Addendum No. 3

Reference: South Garrison Infrastructure Phase II Camp Williams
Utah National Guard
DFCM Project No. 13240480

This addendum is being issued to provide clarifications to the Bid Documents (Drawings and Project Manual) dated June 23, 2014, and to respond to bidder questions.

SHEET NUMBER
EP101-U

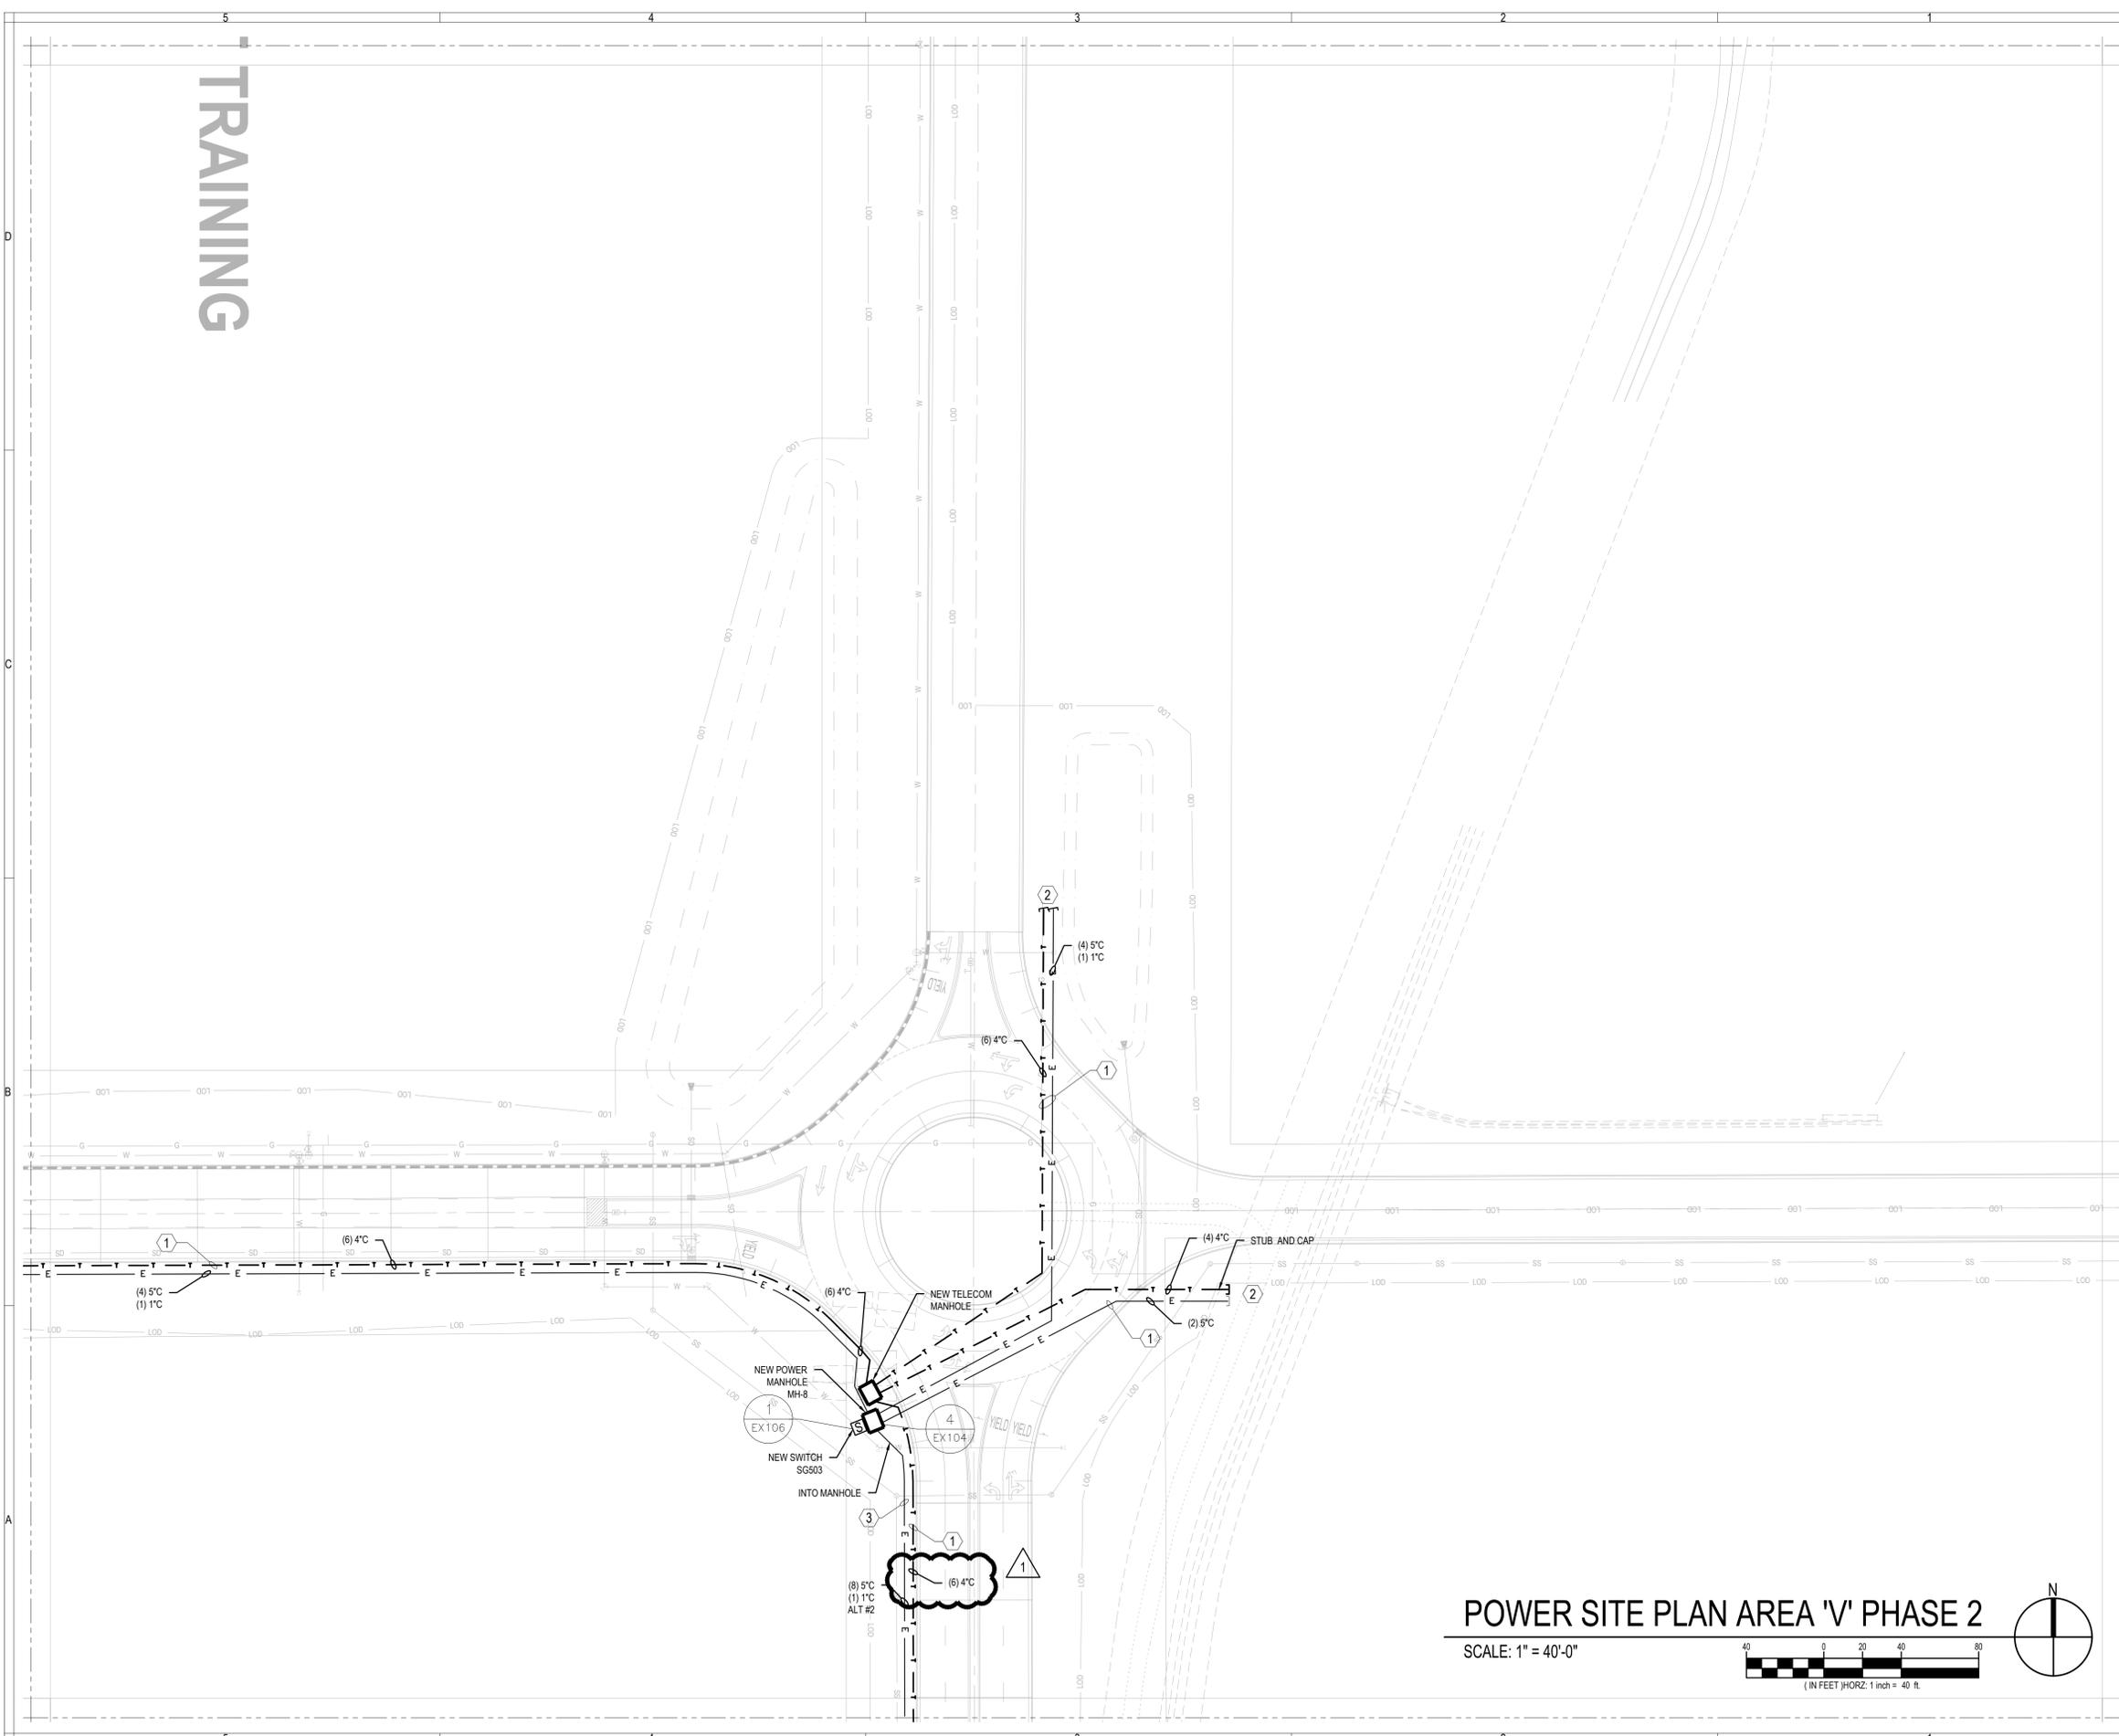
1. Added Keyed Note 6
2. Realigned conduits to match road alignment.
3. Renamed Switch SG502 to SG502A.

- 1 RUN CONDUITS AND PROVIDE PULL ROPE. CONDUCTORS TO BE PROVIDED IN FUTURE.
- 2 STUB UP SPARE CONDUITS 4" ABOVE GRADE. PROVIDE PULL ROPE AND CAP.
- 3 RELOCATE EXISTING SG405 TO NEW LOCATION SHOWN TO FEED EXISTING OVERHEAD POWER. SEE DETAILS ON SHEET EX106 FOR SWITCH VAULTS.
- 4 FURNISH AND INSTALL A NEW DEAD END POWER POLE TO MAINTAIN EXISTING OVERHEAD POWER LINES. DO NOT PROVIDE IF ALTERNATE #2 IS ACCEPTED.
- 5 DO NOT INSTALL SWITCH IF ALTERNATE #2 IS ACCEPTED.
- 6 UTILIZE AVAILABLE SLEEVES AT CANAL CROSSING.

SHEET NUMBER
EP101-V

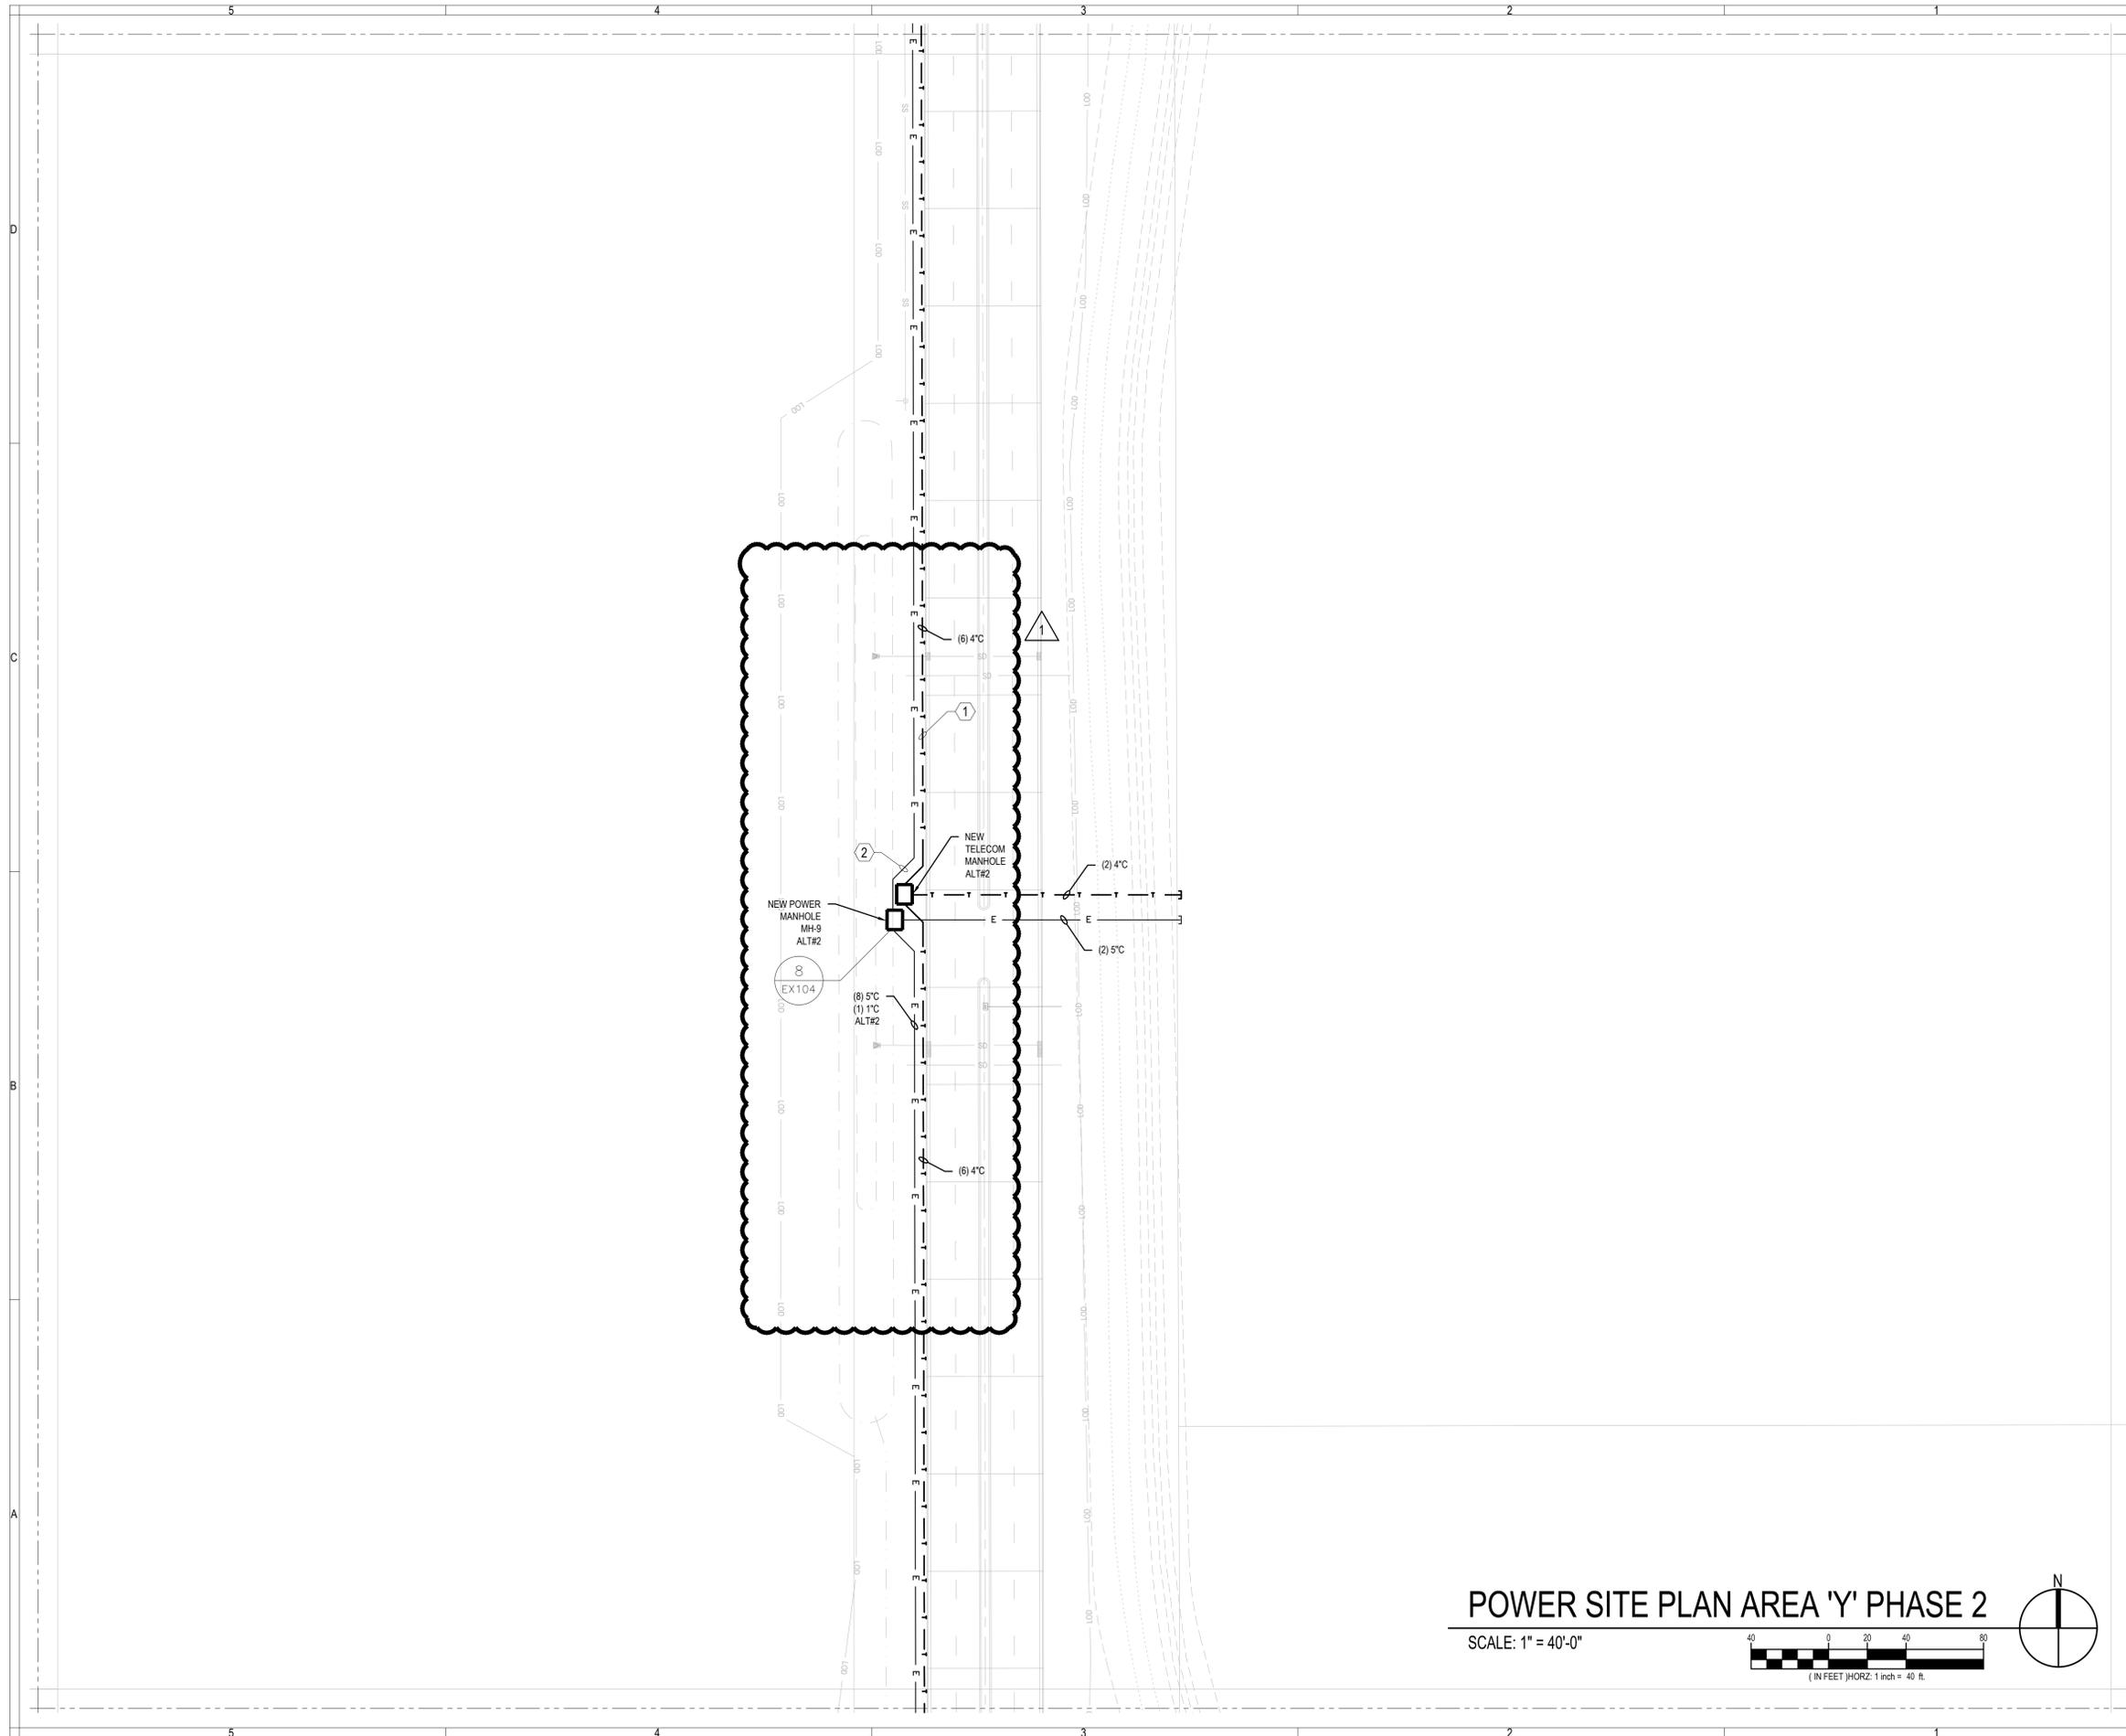
1. Modified Keyed Note 3 to say "Conduit and conductors to be provided as part of Alternate #2."

- ① RUN CONDUITS AND PROVIDE PULL ROPE. CONDUCTORS TO BE PROVIDED IN FUTURE.
- ② STUB UP SPARE CONDUITS 4" ABOVE GRADE. PROVIDE PULL ROPE AND CAP.
- ③ CONDUITS AND CONDUCTORS TO BE PROVIDED IN ALTERNATE #2.

POWER SITE PLAN AREA 'Y' PHASE 2

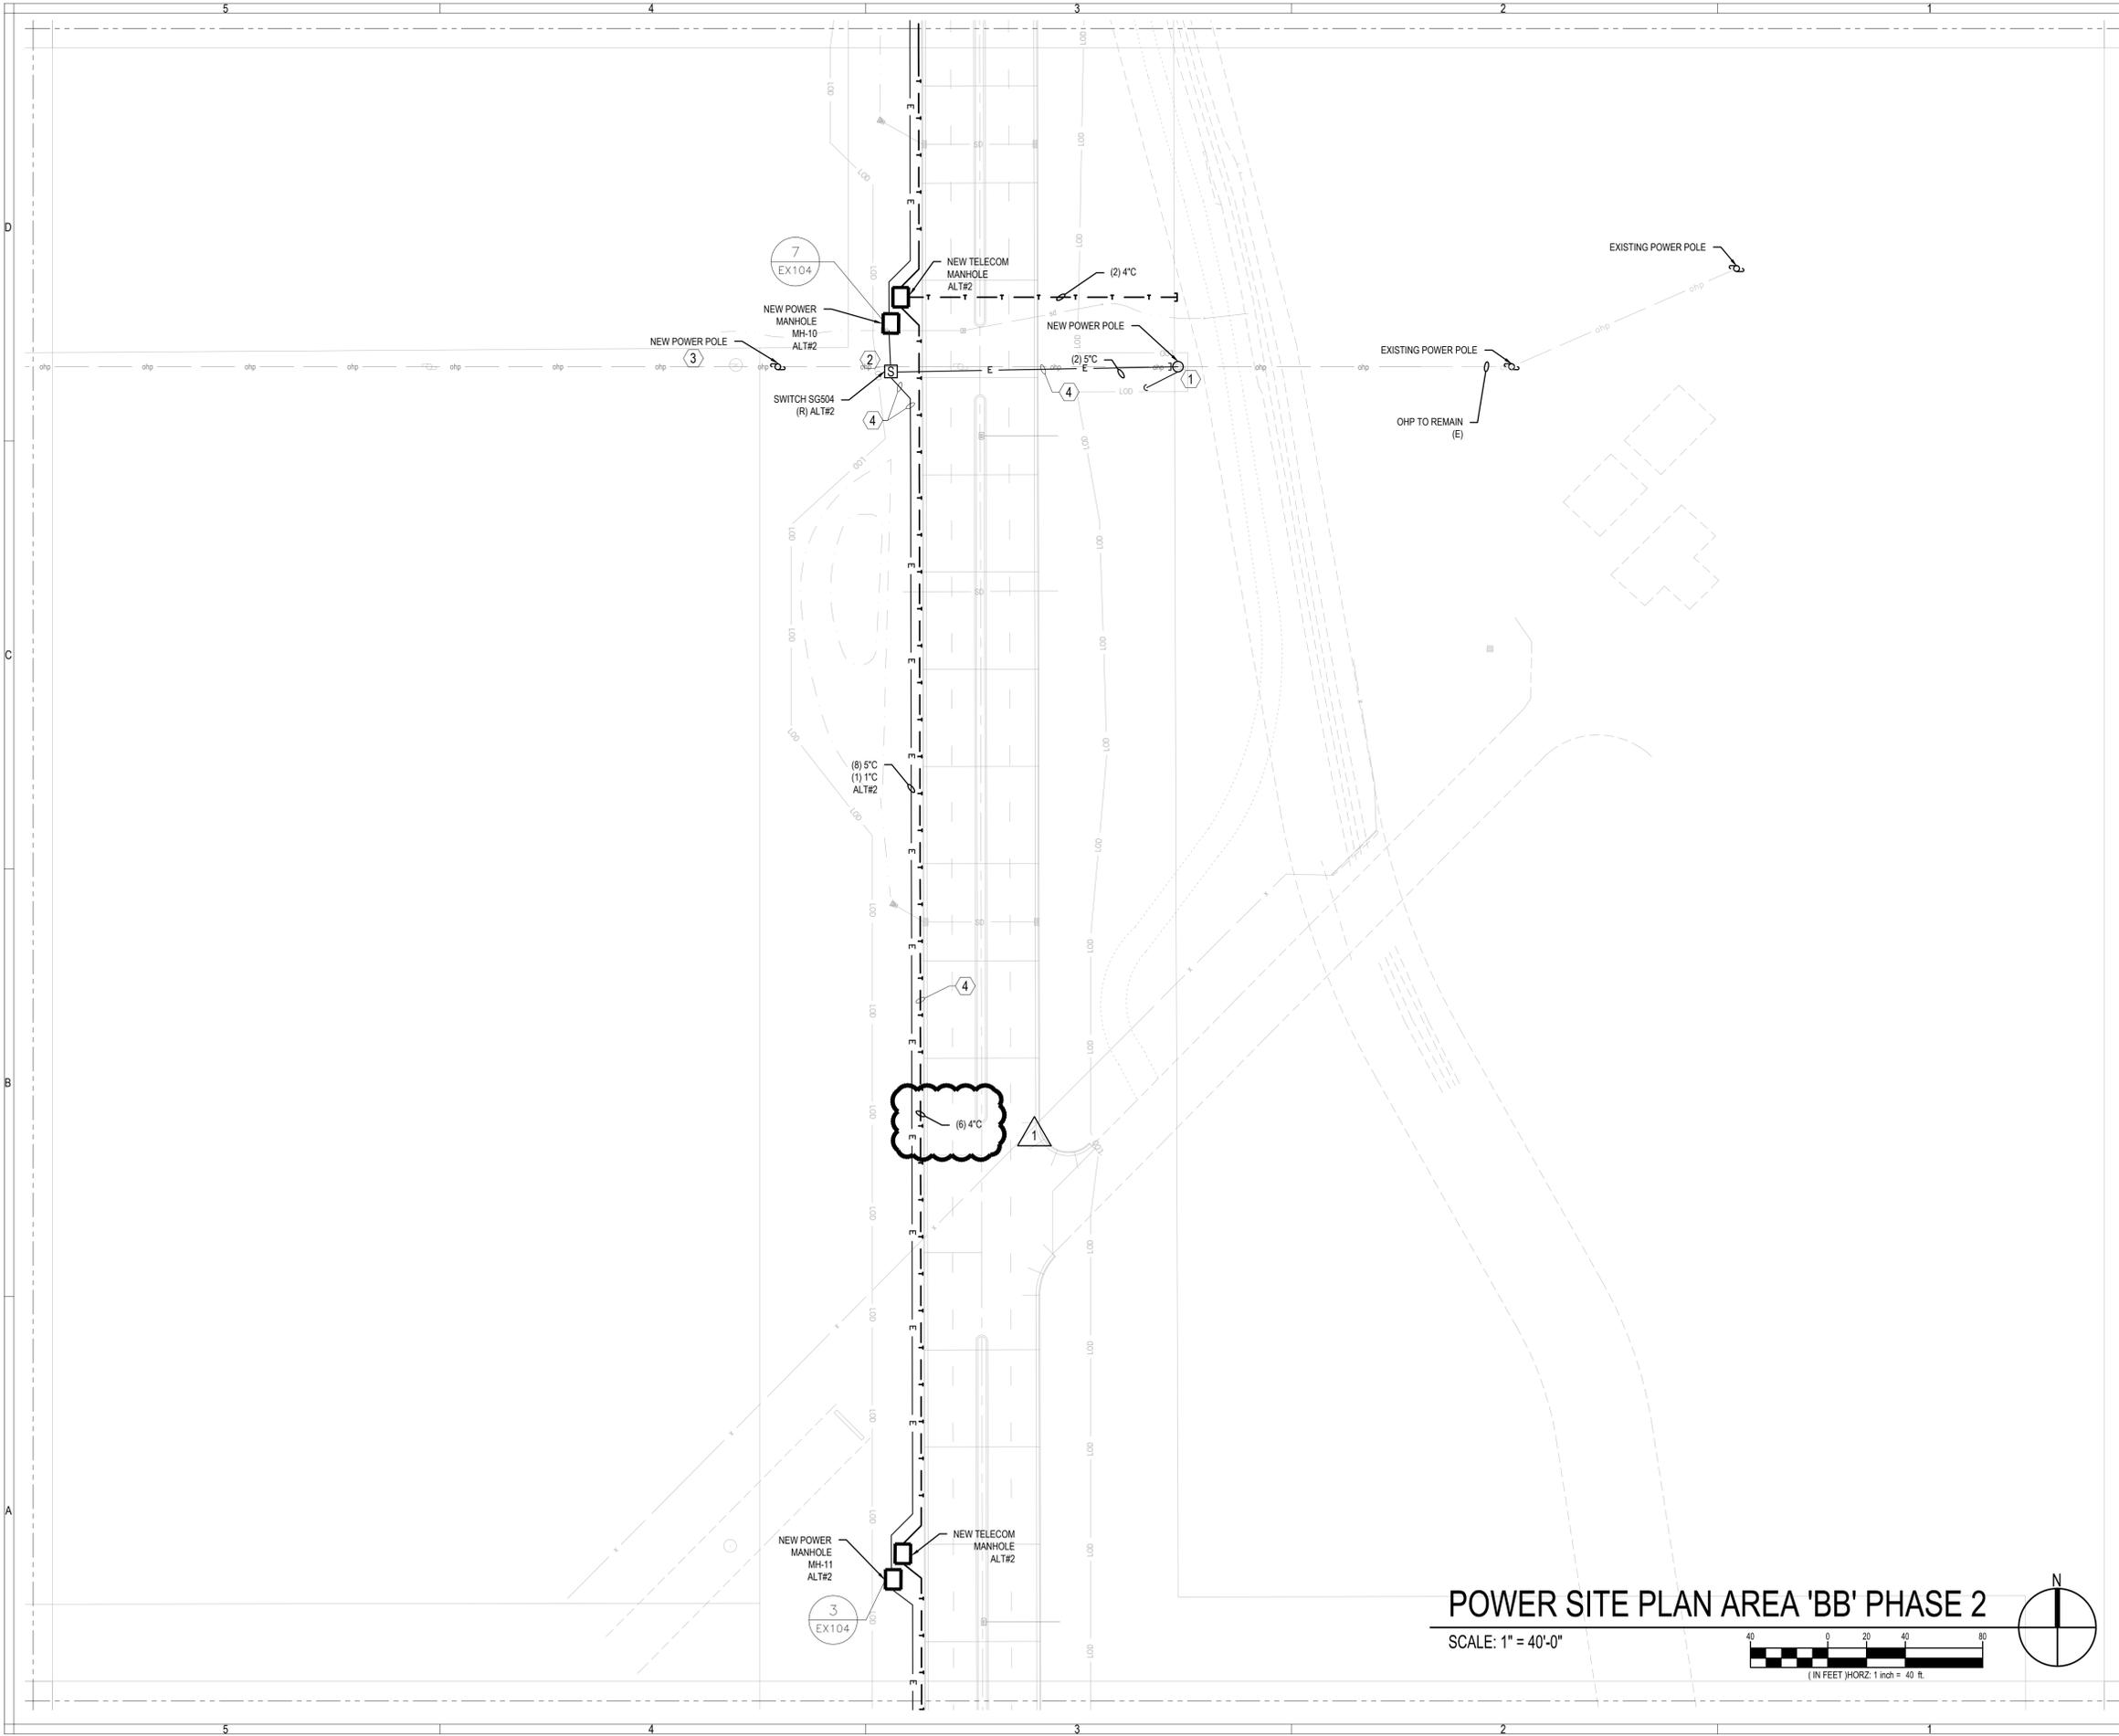
1. Identified telecom conduits as "(6) 4"C".
2. Modified Keyed Note 2 to say "Conduit and conductors to be provided as part of Alternate #2."
